Nevada Health Centers
MLK Family Health
Center / Admin. Offices
SE Corner of Mount Mariah
Drive & Stella Lake Street
Las Vegas, NV

Re: LAND DEVELOPMENT CIVIL PLAN REF. #42467 AND SDR-40766

To: Land Development
From: John Alabado
Phone: (702) 229-6708 Fax: (702) 382-1240
CC: Land Development Civil Plan Ref. # 42467
Date: 6/18/11 1st Review
Re: Nevada Health Center – Civil Revision

RE: SDR-40766 – SITE DEVELOPMENT PLAN REVIEW
CITY COUNCIL MEETING OF APRIL 6, 2011

ARCHITECTURAL SITE PLAN
SCALE: 1" = 20'-0"

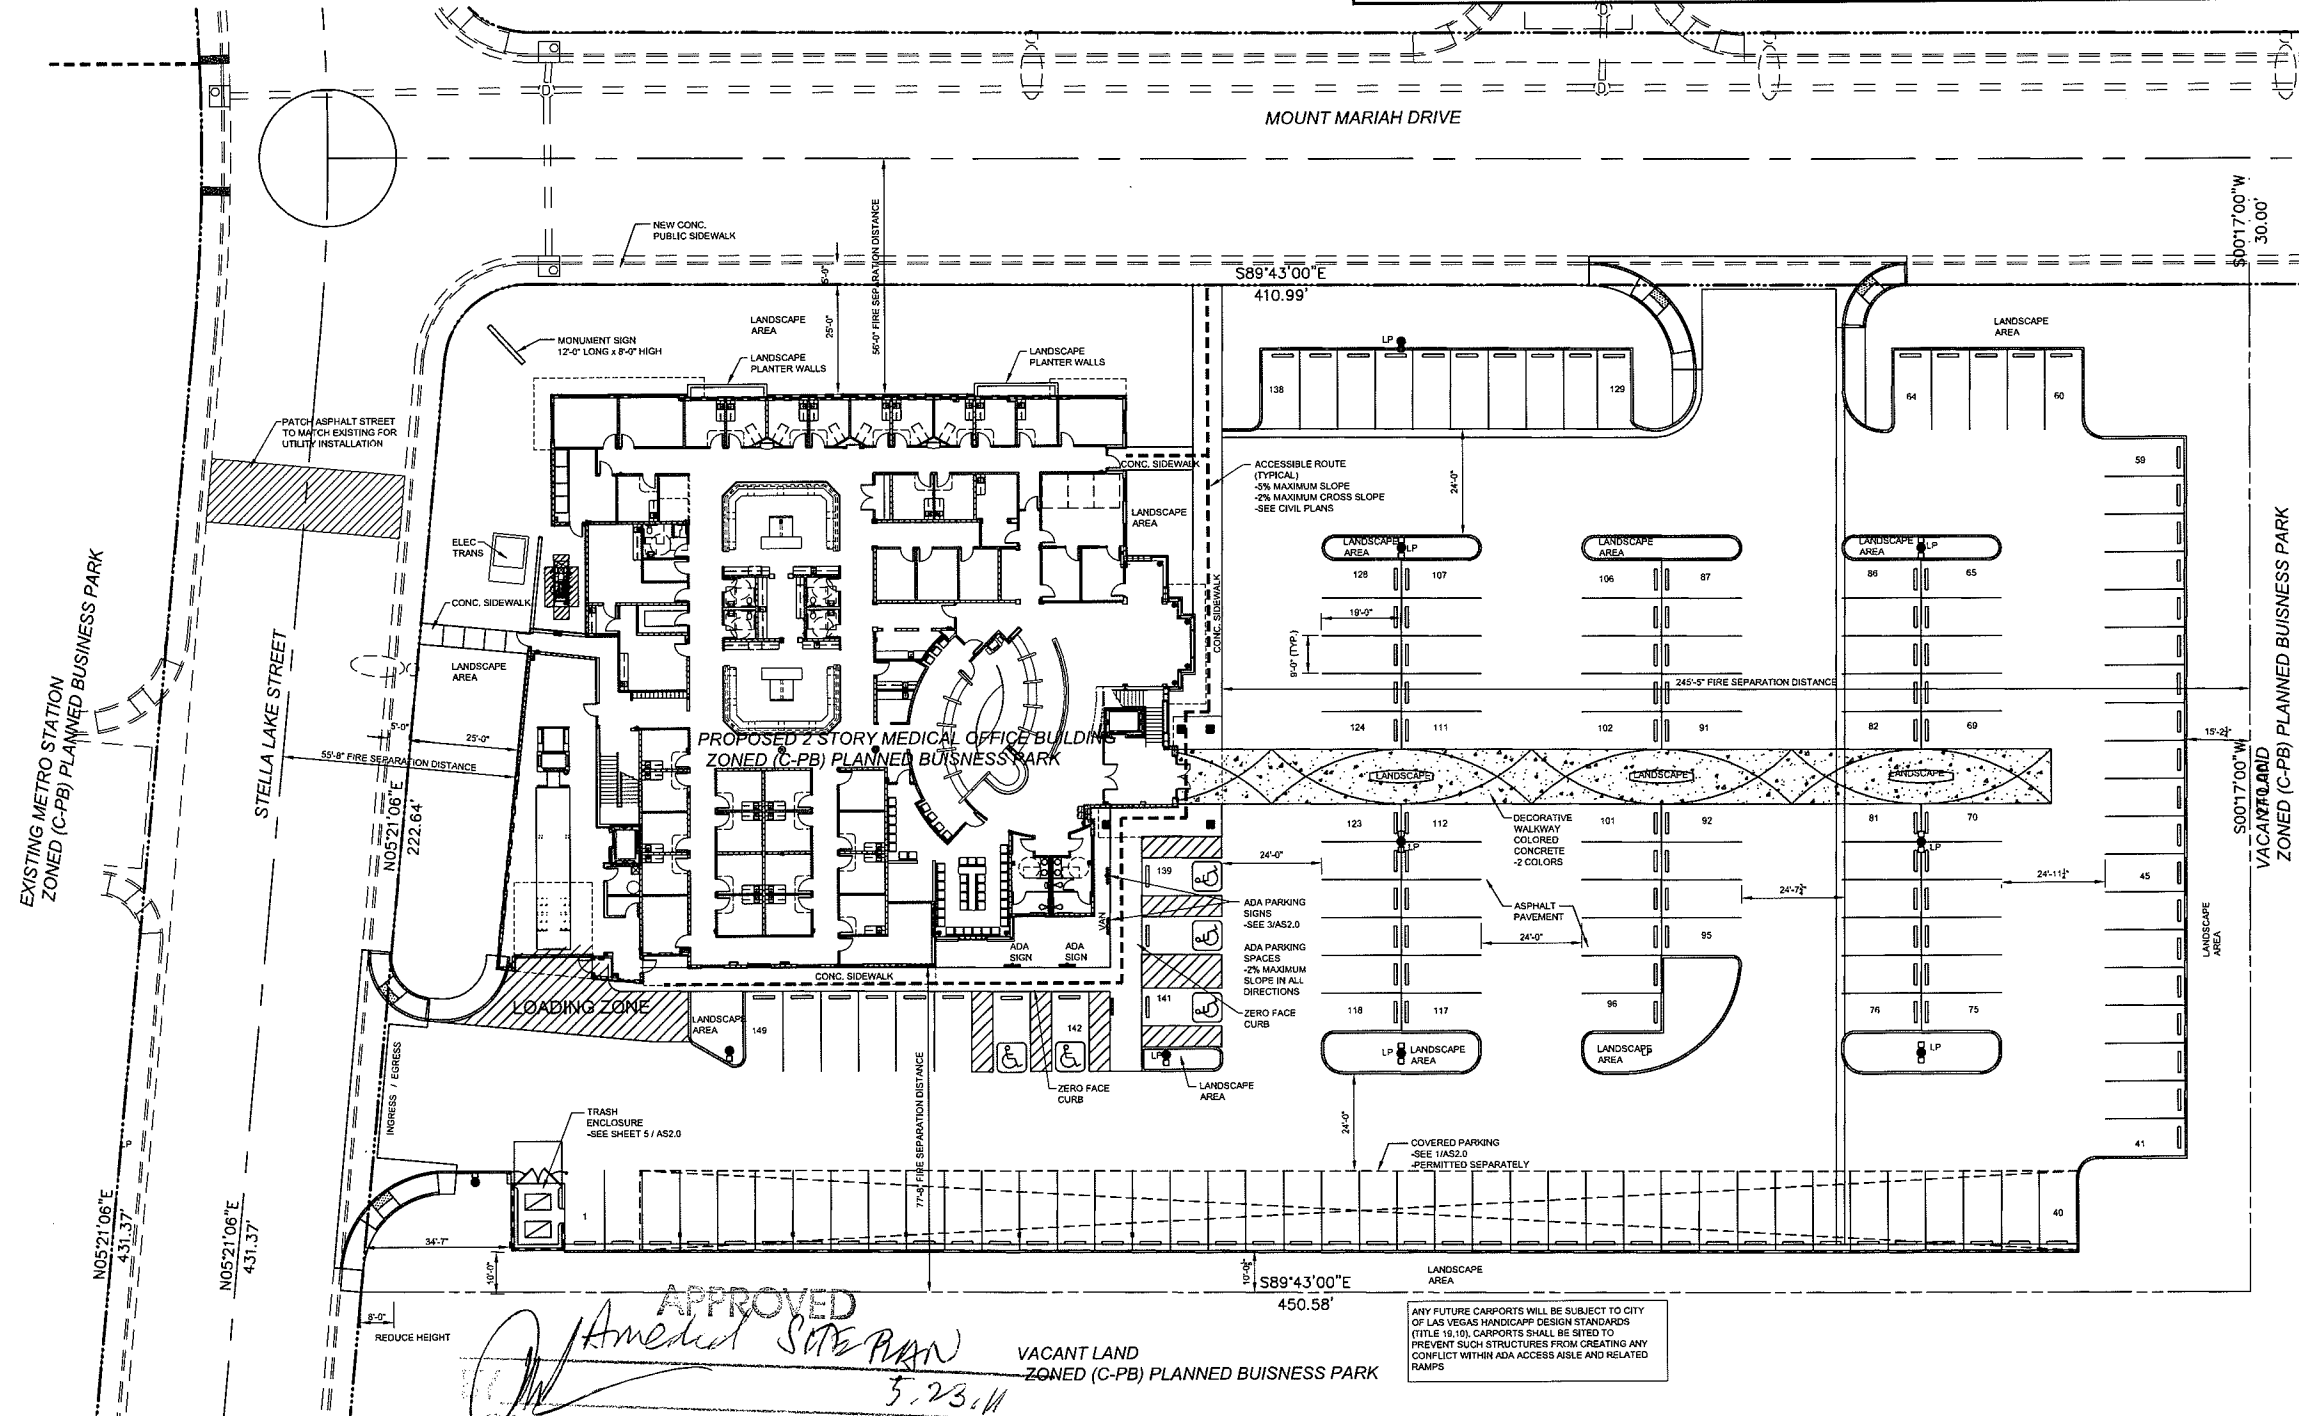
1. An amendment to Site Development Plan Review (SDR-40766) is required prior to approval of the Civil Revision for changes to parking and landscaping.
2. The proposed removal of landscaping from the landscape plan requires an Exception from Title 19.10 Parking Lot Landscape requirements. Please identify the total number of parking lot trees proposed and the amount of trees loss that will deviate from the initial Exception granted for landscaping under SDR-40766. A total of 15 trees was approved in the exception under SDR-40766. Please submit one copy of the revised Landscape/Site Plan that includes an updated plant palette.
3. Please submit a letter requesting the amendment and Exception with detailed justification for the parking and landscape changes.

Enclosed are the revised site plan and landscape plan that show revisions to the previously approved site plan referenced above. These changes are a result of a requirement for NVHC to provide parking for a neighboring property, "FIT". This was part of a condition that NVHC agreed to as part of the land purchase from the City of Las Vegas. There was a misunderstanding during the original planning process that the required space need to be available, but not over and above the required amount of parking required to service the building. We recently were made aware that the spaces are to be dedicated and need to over and above the required parking.

The revised site plan adds the necessary parking to accommodate the agreement and the landscaping has been adjusted accordingly. Please note that the landscaping has not been reduced, but it has been relocated slightly to accommodate the new layout. We have not added additional ADA spaces because these additional spaces are not for the use of NVHC. The additional ADA spaces should be required at the facility across the street, which these additional spaces serve.

PLANTING PLAN

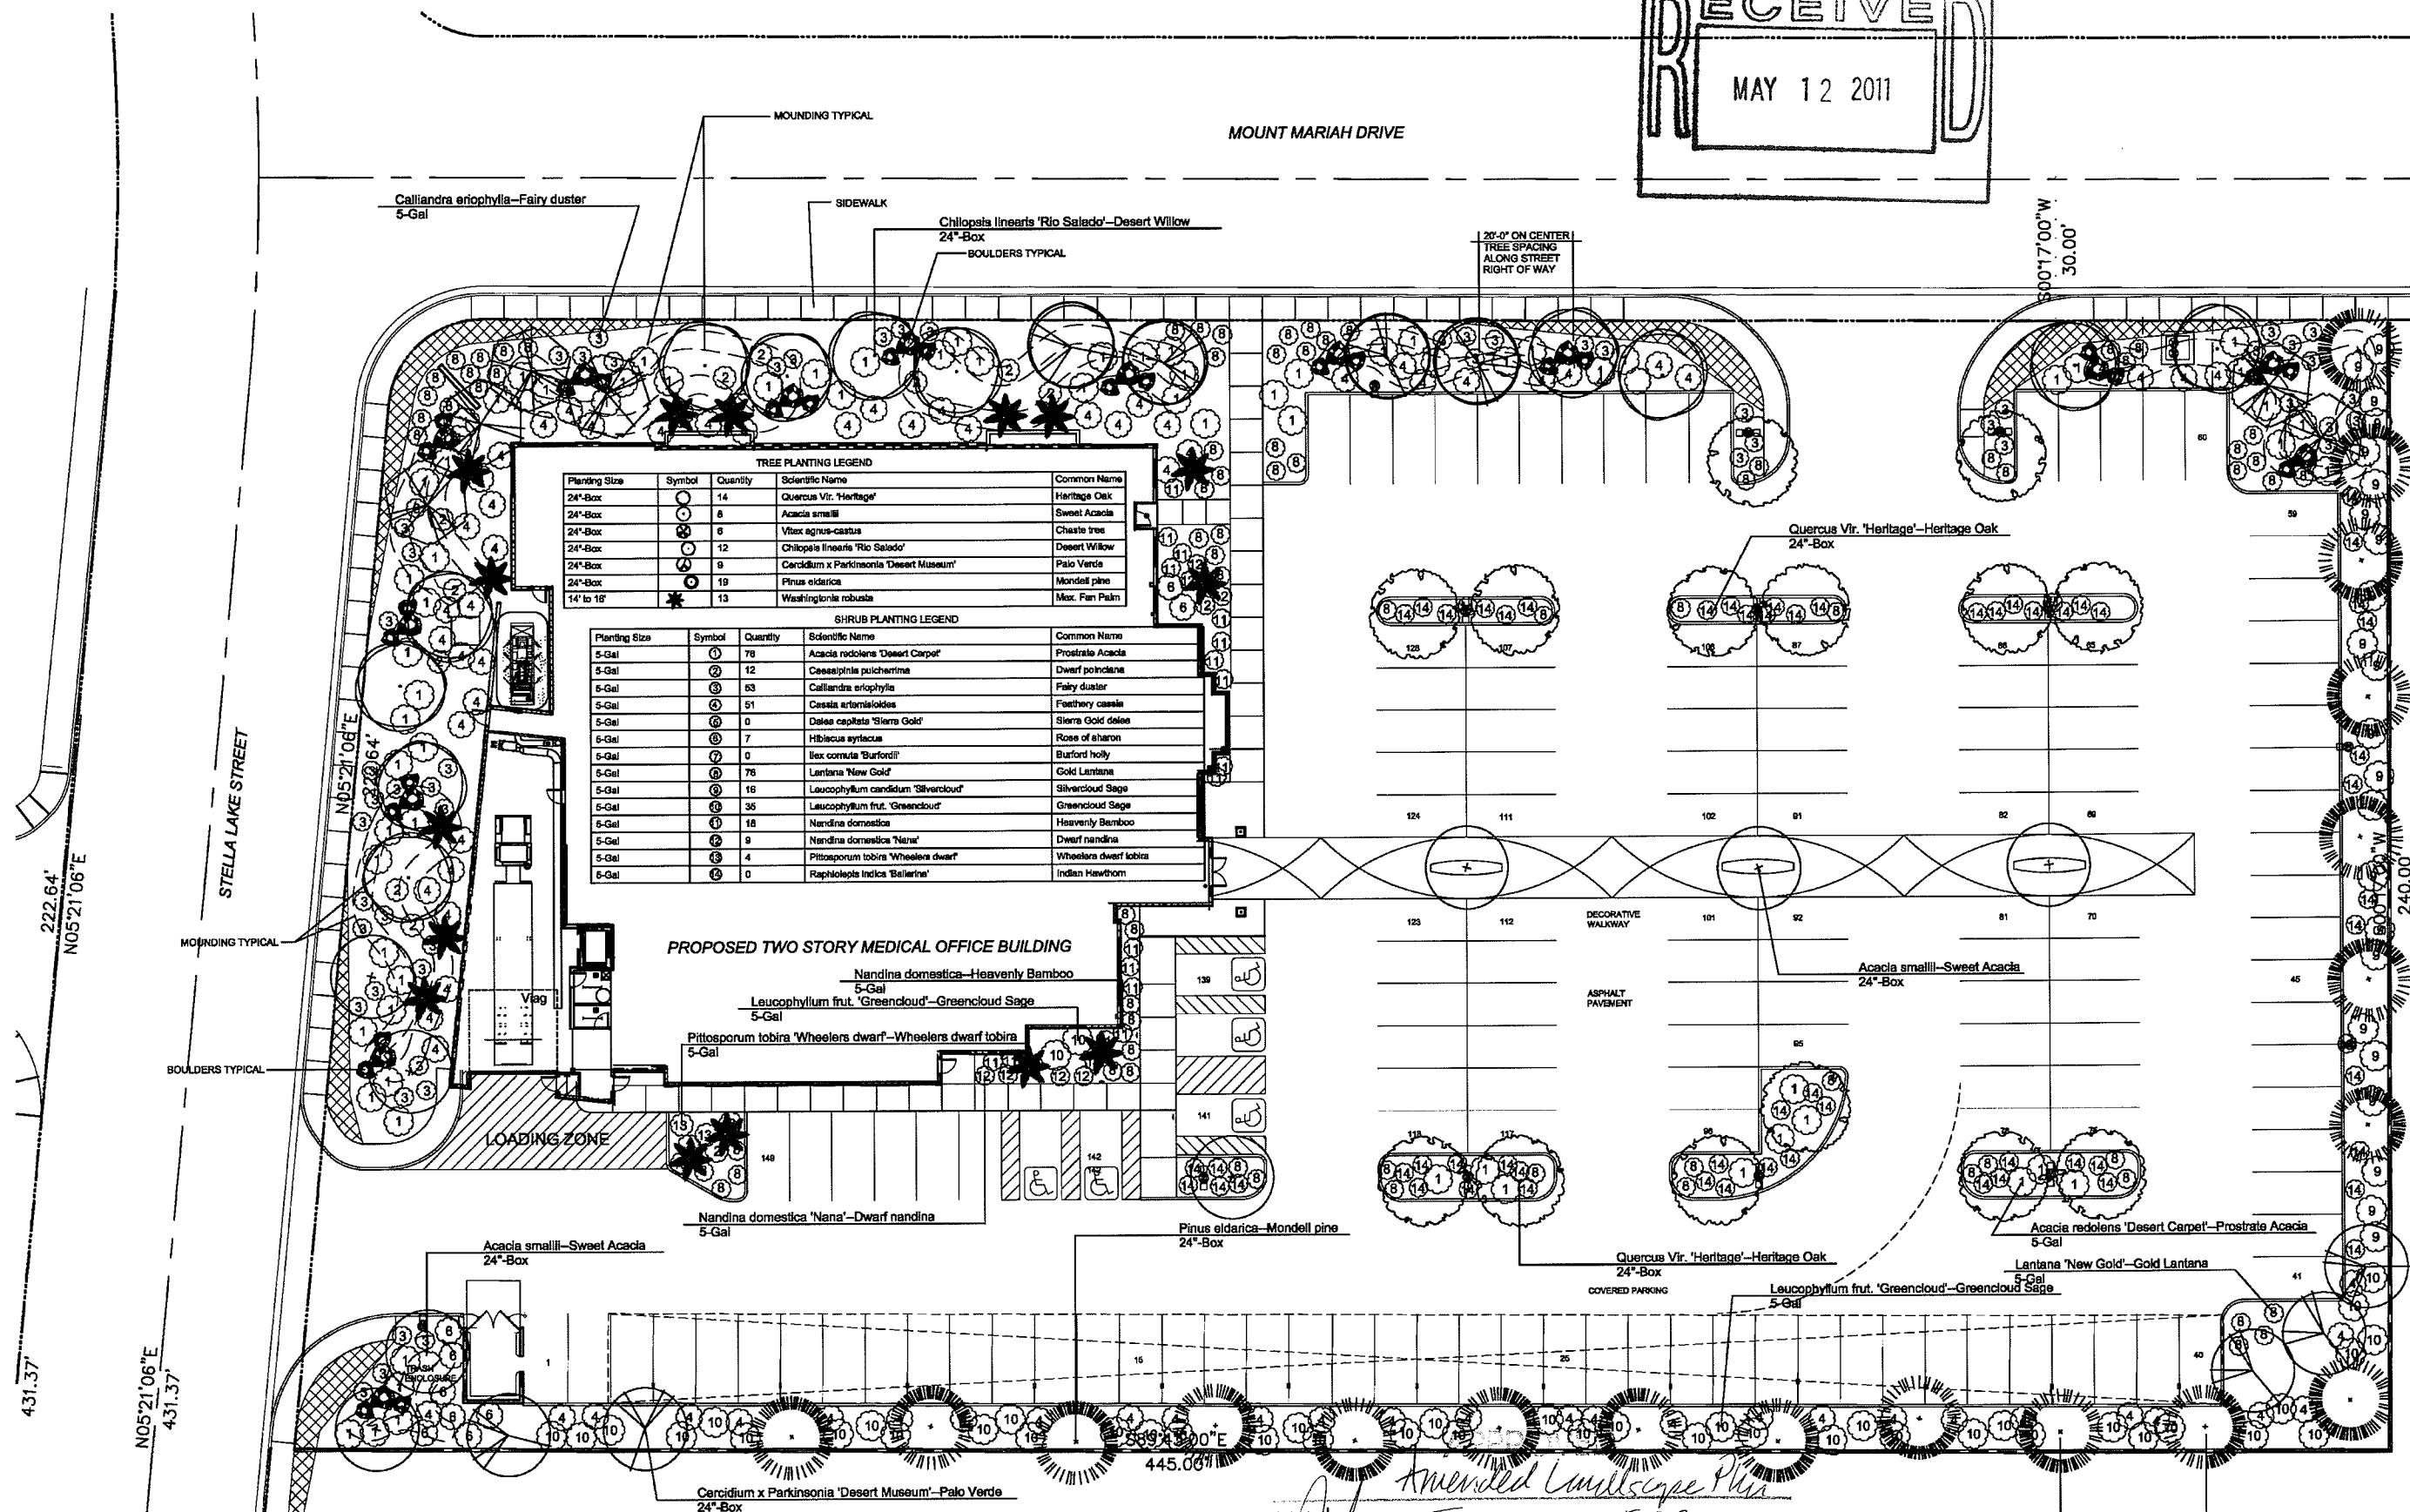
Revisions to the Landscape Plan were made to add 5 gallon shrubs for each tree thereby enhancing the Landscape Planting Plan and bringing the project into greater conformance with Title 19.12 and 19.10 Landscape/Parking Landscape Standards. Additionally the property line walls have been eliminated from the project as the proposed City Fire Station to the south will include construction/installation of a wrought iron fence. Drainage engineering concerns warranted the removal of this project feature.

9.) The landscape plan has been revised to include the minimum number of shrubs.
